**S-TYPE**

S307-07

SERVICE**TECHNICAL BULLETIN**

Harsh/Slow Shifts –
3.0 L V6 Vehicles –
Reprogram PCM

ILLUSTRATION 1

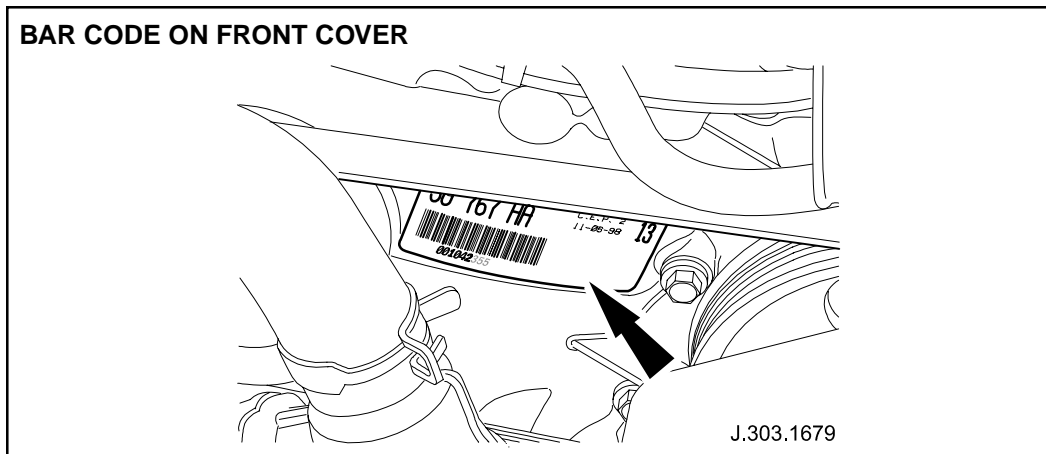
Note: The engine number is located on the bar code label on the engine front cover (Illustration 1) or on the left-hand side of the engine bedplate (Illustration 2). Position the vehicle on a lift as needed to gain access.

ILLUSTRATION 3

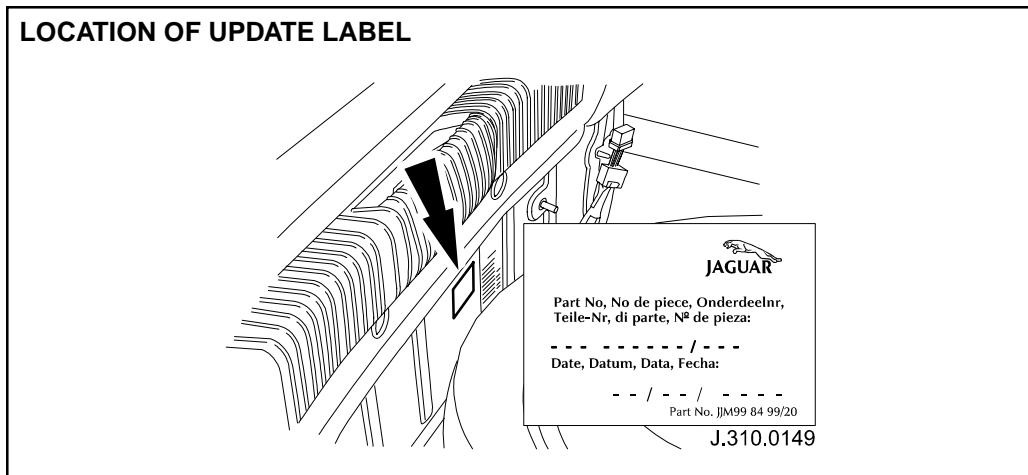
Note: While WDS is re-programming PCM, apply generic update label (JJM 998499/20) alongside the VCATS label in the trunk with revised part number (from table below), and date of re-configuration added to label (Illustration 3).
